# Lake Auburn Watershed Protection Commission

Wednesday, September 14, 2022 at 3:30pm – 5:30pm AVCOG, 125 Manley Road, Auburn,  
Maine

#### **c. Peer review update on the Gracelawn property**

Figure 1 Previous (black dashed) and revised (blue) watershed delineation per FP Environmental (2021)

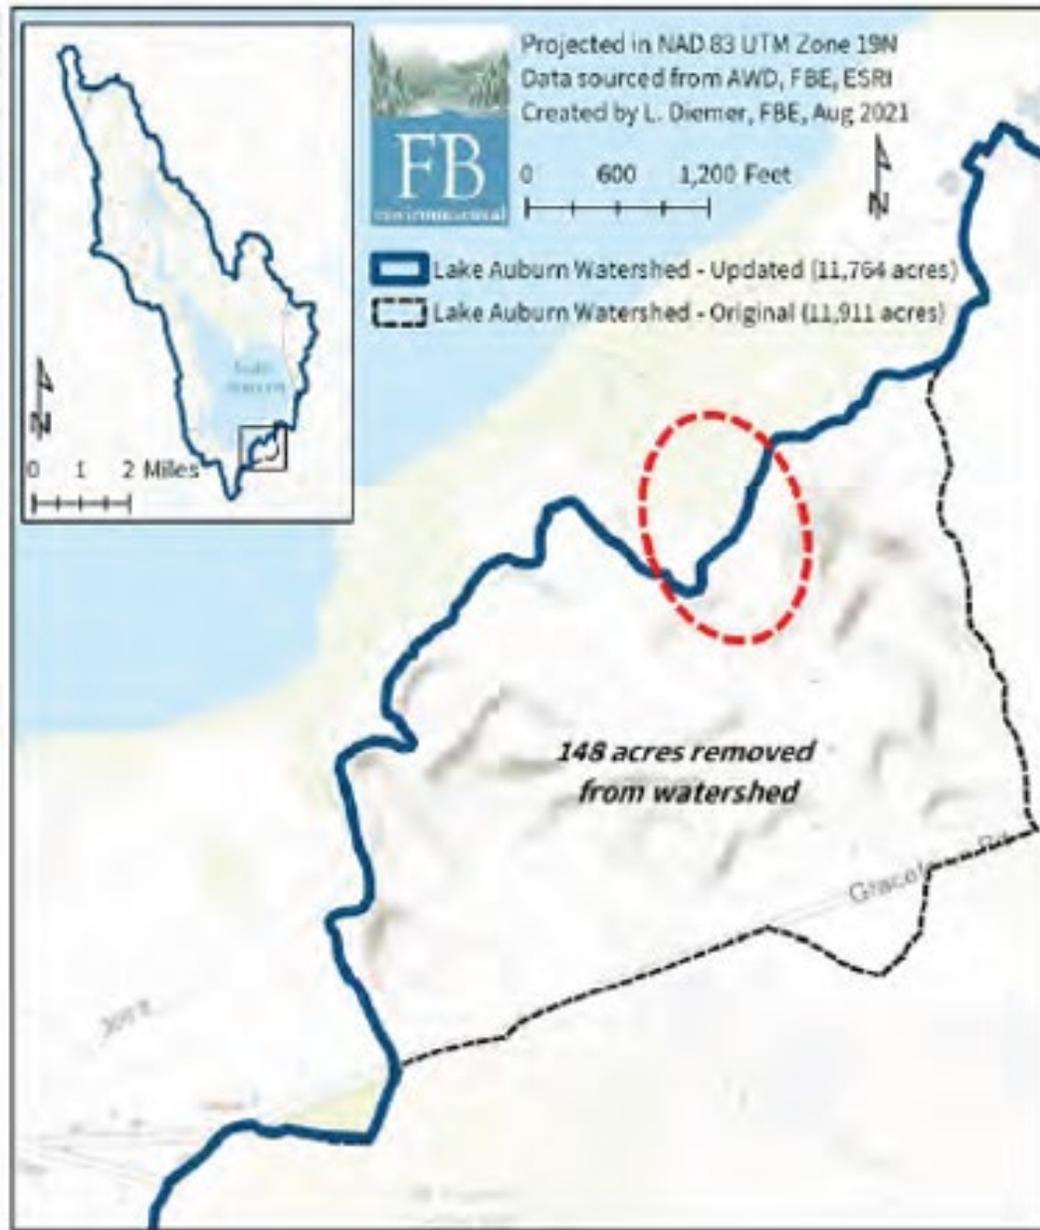
The watershed delineation was moved northward, closer to the lake, removing approximately 148 acres from the estimated watershed. **Figure 1** shows the previous and revised delineations as presented by FB Environmental. **Figure 2** shows an approximation of these delineations sketched onto an aerial photo. The area between the old and proposed new delineations includes a number of sand and gravel borrow areas on the west side and former City of Auburn landfill and dump areas to the southeast

As part of an environmental and regulatory analysis of Lake Auburn water supply protection (FB Environmental, 2021), a revised watershed delineation of the watershed near the southeast shore of the lake was presented which reduced the watershed area by 148 acres (**Figure 1**).

Figure 3 Land use zones

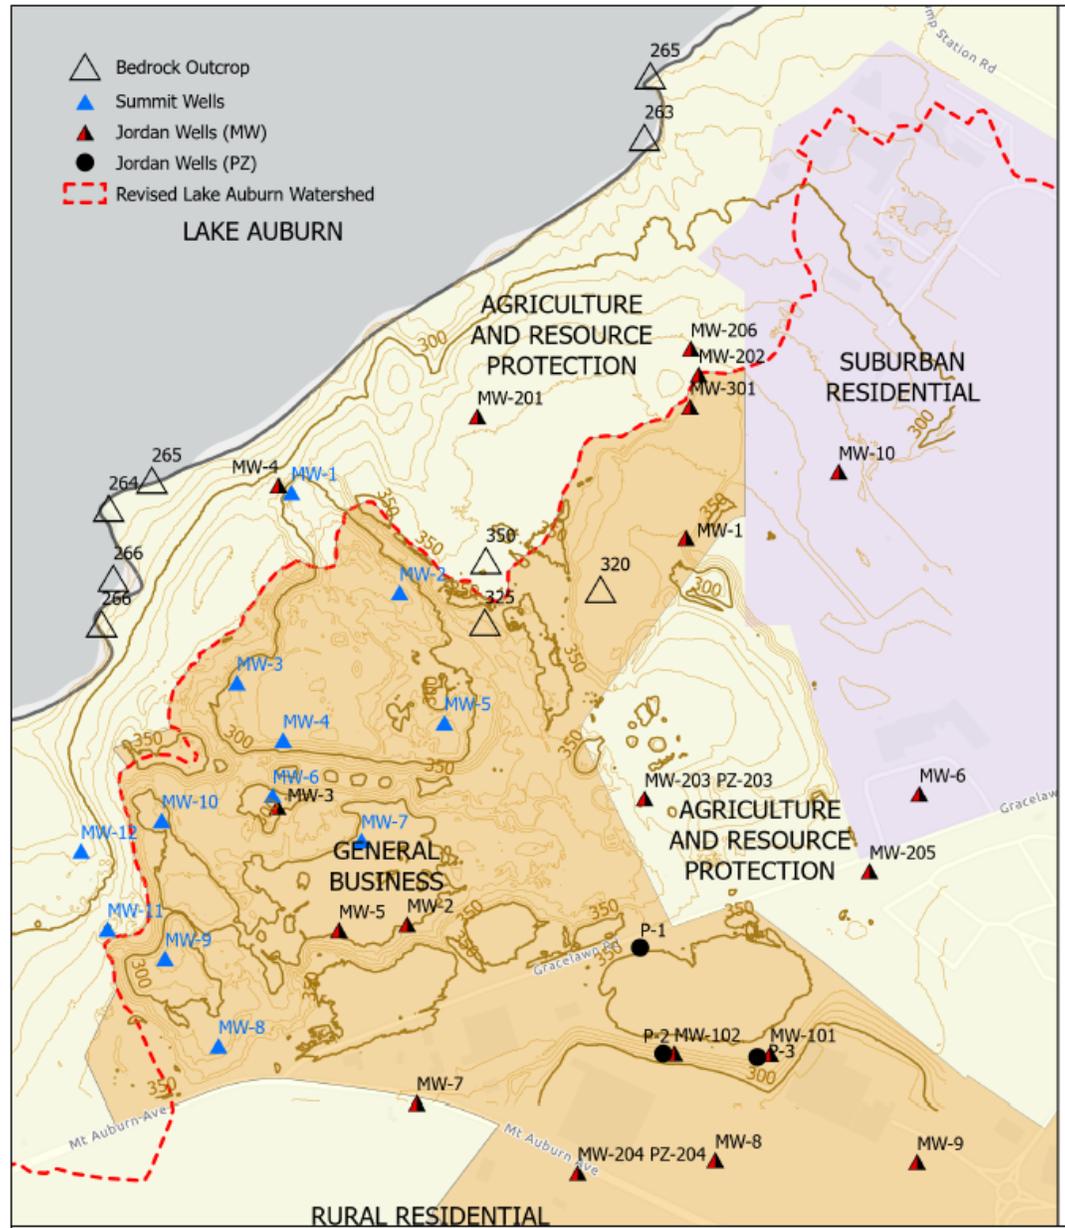
The recently proposed City of Auburn land use zoning change for this parcel is generally consistent with the revised watershed delineation, as shown in **Figure 3**. The area within the newly delineated watershed is generally shown to be in a “Resource Protection” zone, while much of the area just outside of the revised delineation is shown to be in a “General Business” zone.

- Bedrock outcrops at the shoreline with surface elevations 264-266 feet MSL shown in **Figure 3** indicate a rise of the bedrock surface near the shore. The relatively elevated bedrock here might significantly limit the hydraulic connection between the overburden aquifer and the lake, which has a water surface elevation of approximately 260 feet MSL.

Figure 5 Bedrock surface contour map from E.C. Jordan (1990)

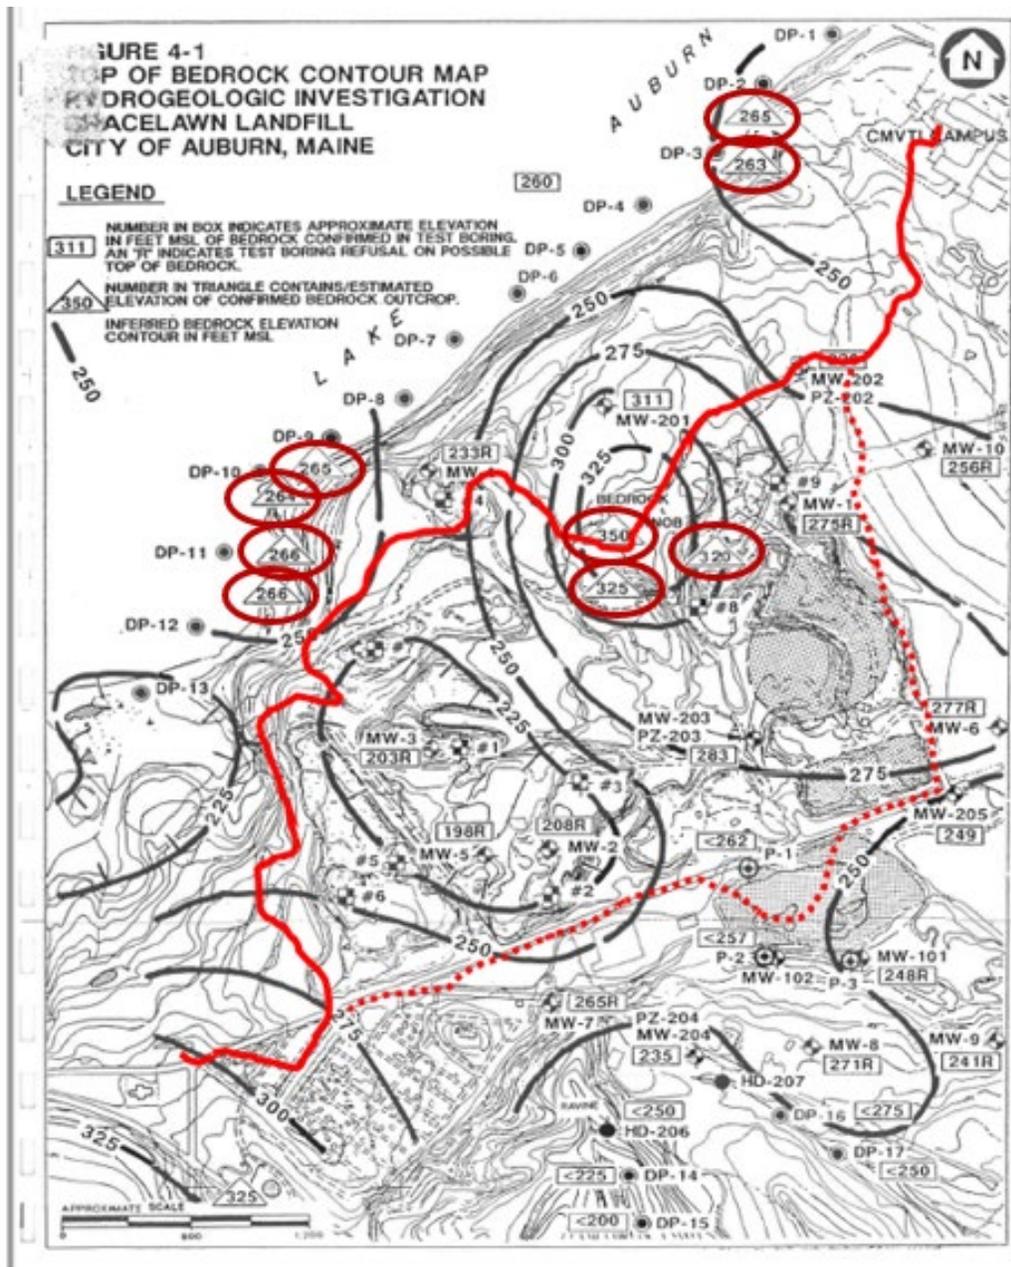
**Figures 5 and 6** show bedrock surface contours as presented by E.C. Jordan (1990) and Woodard and Curran (1995), respectively. In **Figure 6**, bedrock surface contours are shown only for the northeast part of the study area (orange circle). Seismic survey lines in that area are also shown. The contours in both figures were developed based on seismic surveys, boring logs and surveyed elevations of outcrops. Though it is not stated how the thin till layer might affect the seismic data and refusal in borings, the delineated bedrock surface should be reasonably representative of the bottom of the sand and gravel overburden aquifer, except at the identified outcrops areas where the overburden aquifer does not exist.

- Near the center of the study area is an area of high bedrock, labeled “bedrock knob” in **Figure 5**. The area includes outcrops, indicated by triangles in the original figure, circled in red in **Figure 5**. Outcrop surface elevations of 350, 325 and 320 feet mean sea level (MSL) are shown. The reported bedrock surface at MW-201, just north of the outcrops, is also greater than 300 feet.
- The bedrock surface appears to decline most steeply from the “knob” area to the north and northwest towards the lake, and to the southwest.

Figure 6 Bedrock surface contours from Woodward & Curran (1995)

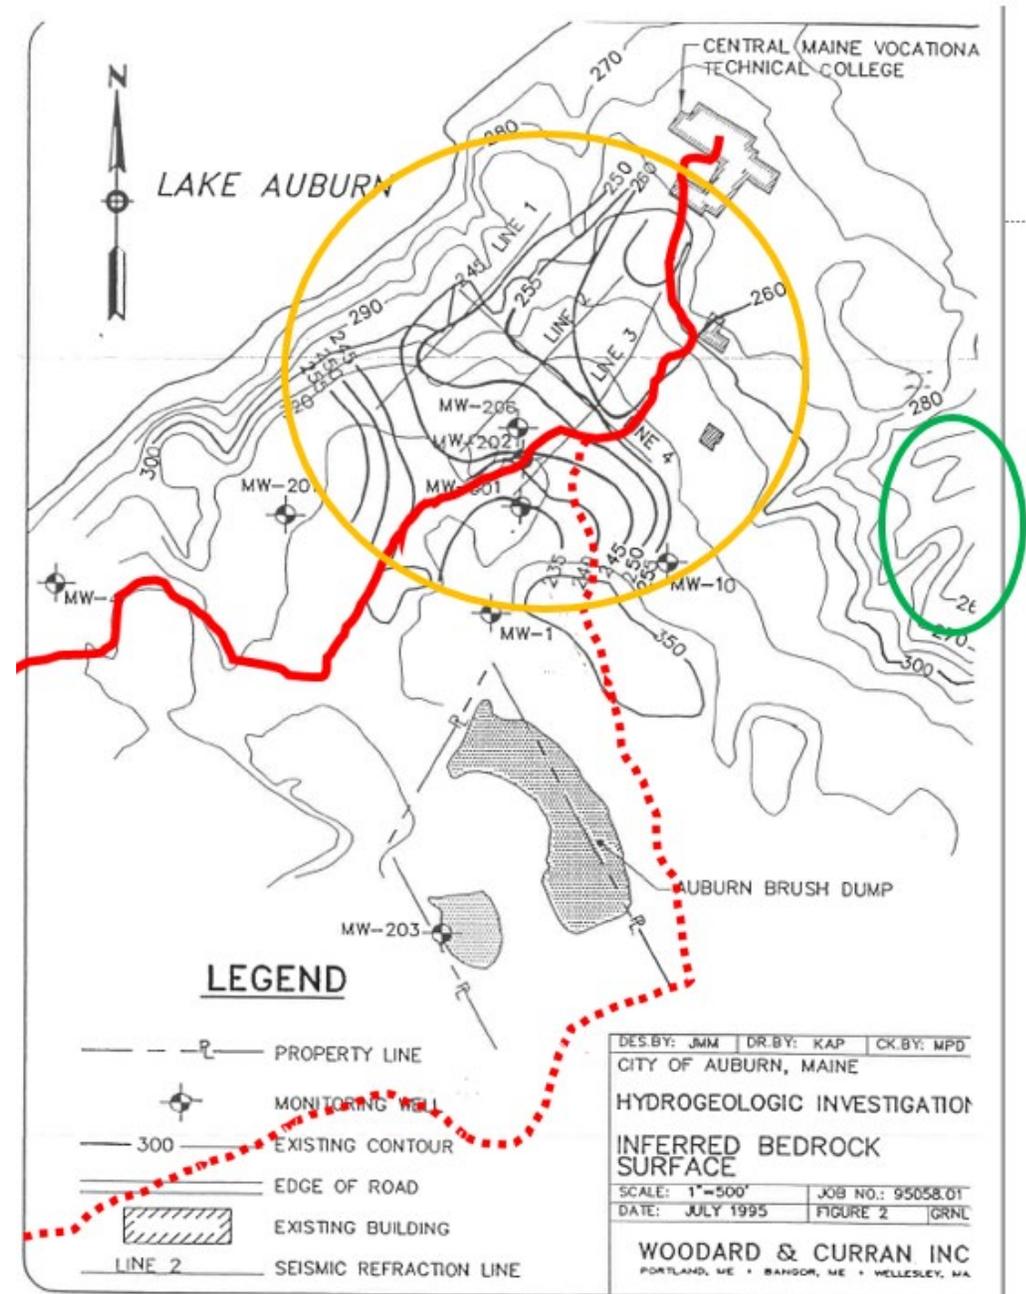
- **Figure 6** shows bedrock surface elevation contours for this area presented by Woodard and Curran (1995). These are based on boring logs and the seismic survey. The contours indicate the bedrock surface is lower than 250 (and as low as 235) feet MSL at MW-202, MW-206 and MW-301, approximately 900 feet east of the knob, indicating a significant decline.

- The contours indicate a subsequent rise in the bedrock surface to elevations greater than 260 feet MSL farther to the northeast.
- Note that the contouring shown in **Figure 6** does not account for the higher bedrock surface estimated at MW-1, approximately 500 feet south of MW-301, to be 275 feet MSL.

- The green circle at the eastern edge of **Figure 6** highlights locations where the topographic contours indicate areas where the ground surface is less than 260 feet. The area is highlighted in **Figure 6** because subsequent figures in this report do not extend that far to the east.

Figure 9 Subarea C: West monitoring wells

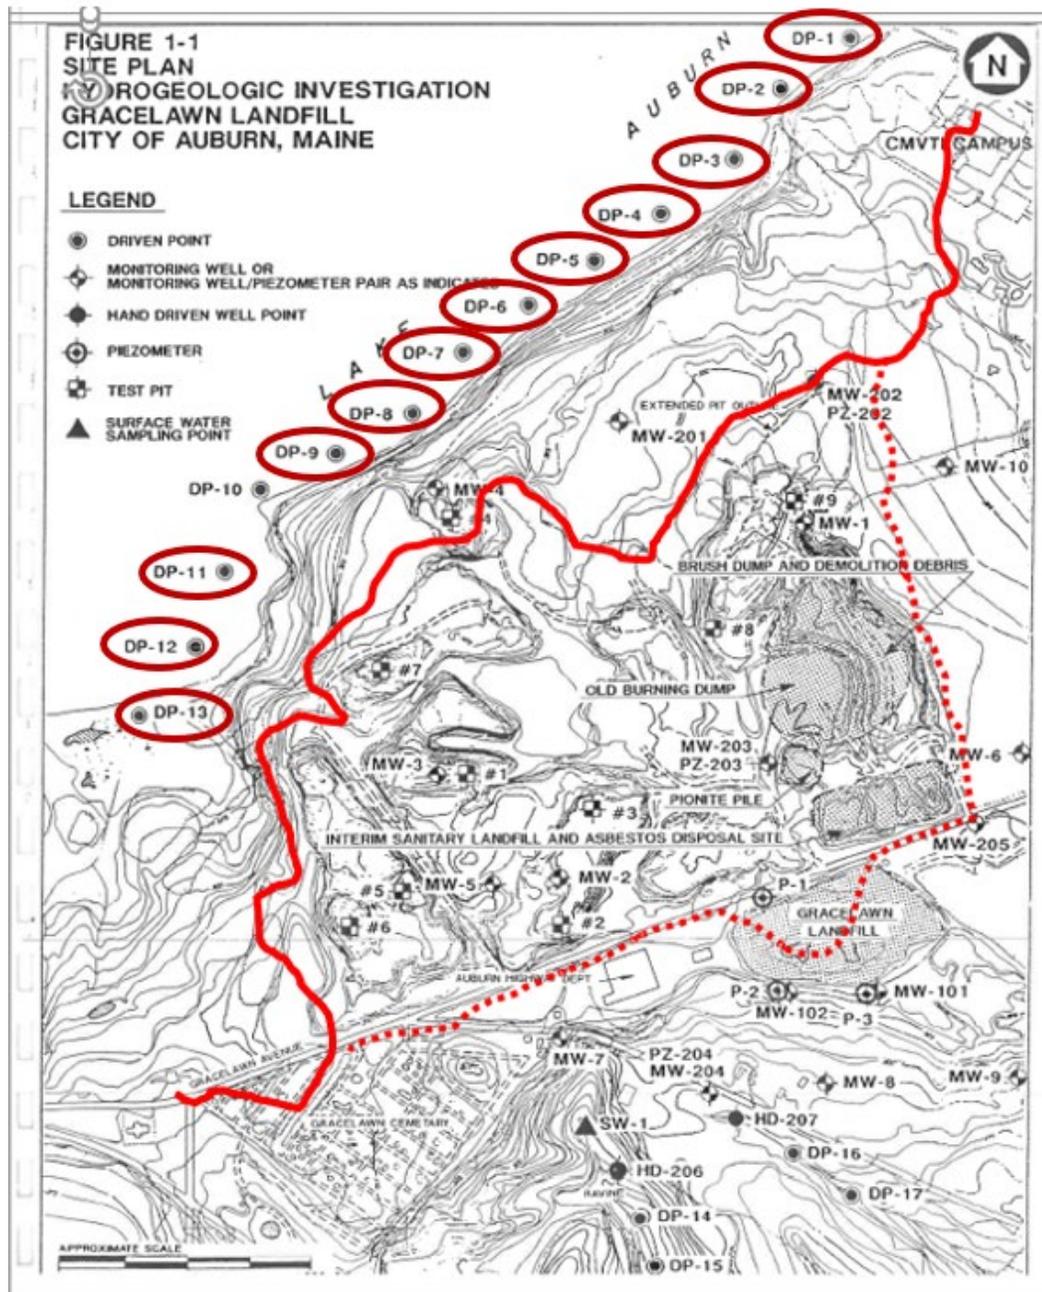
- Data for the easternmost Summit wells, MW-2 and MW-5 (dashed green circles in **Figure 9**), indicate that both the bedrock surface and groundwater levels exceed the lake water level (maximum reported groundwater level 271 at MW-5).

Figure 10 Subarea D: Gracelawn Landfill monitoring wells and MW/PZ-203

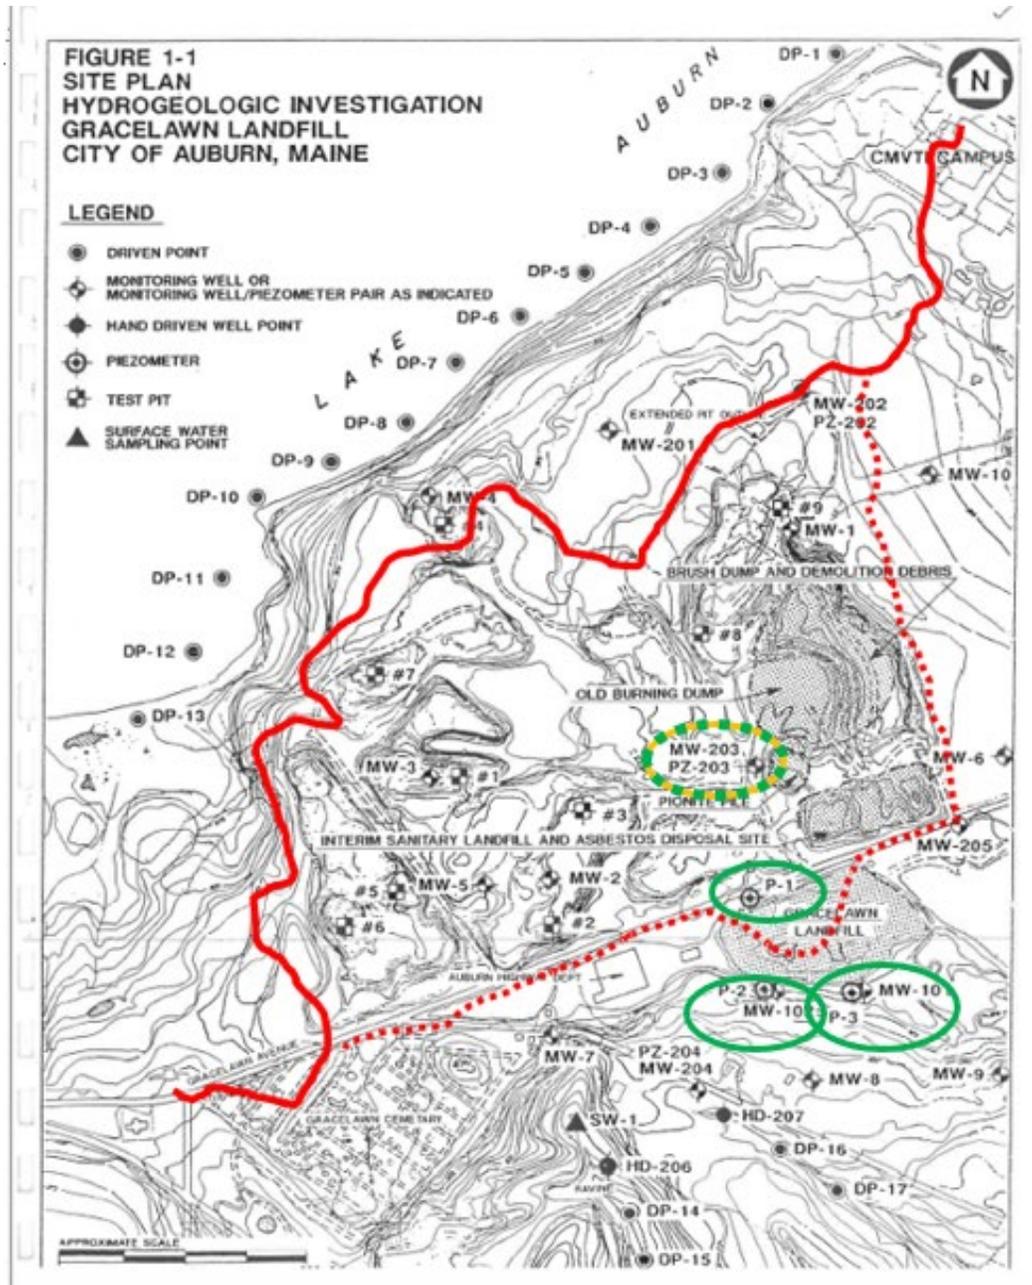
- Southerly flow away from the Lake is indicated in the vicinity of the Gracelawn Landfill by groundwater levels measured at piezometers P-1, to the north, and P-2 and P-3 to the south of the landfill. The piezometer locations are circled in **Figure 10**.
